XT and XTL Series Panels

October 2013

Version 116 Software Update

Enhanced Weather Display

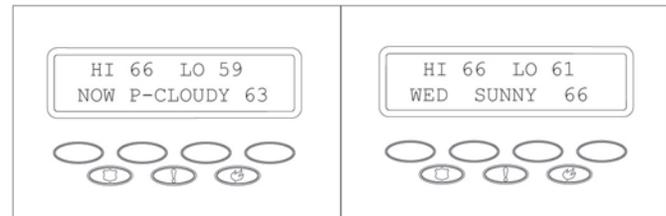
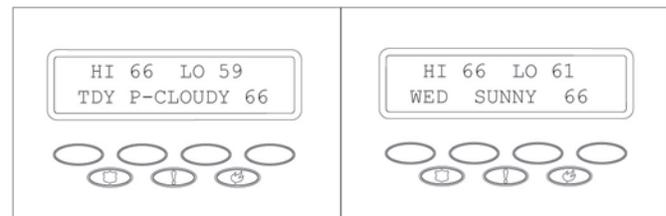
The weather information displayed in the 32 character keypad status list has been enhanced to include additional information.

Previously, the keypad displayed:

- The current weather condition and temperature
- Tomorrow's forecast condition and temperature

For network enabled panels, weather information is updated every hour and the keypad displays the following:

- Today's forecasted high and low temperatures
- The current weather condition and temperature
- Tomorrow's forecasted high and low temperatures
- Tomorrow's forecasted weather condition

Panels with a cellular connection update four times daily and display TDY in place of NOW followed by today's forecasted weather condition instead of the current condition.
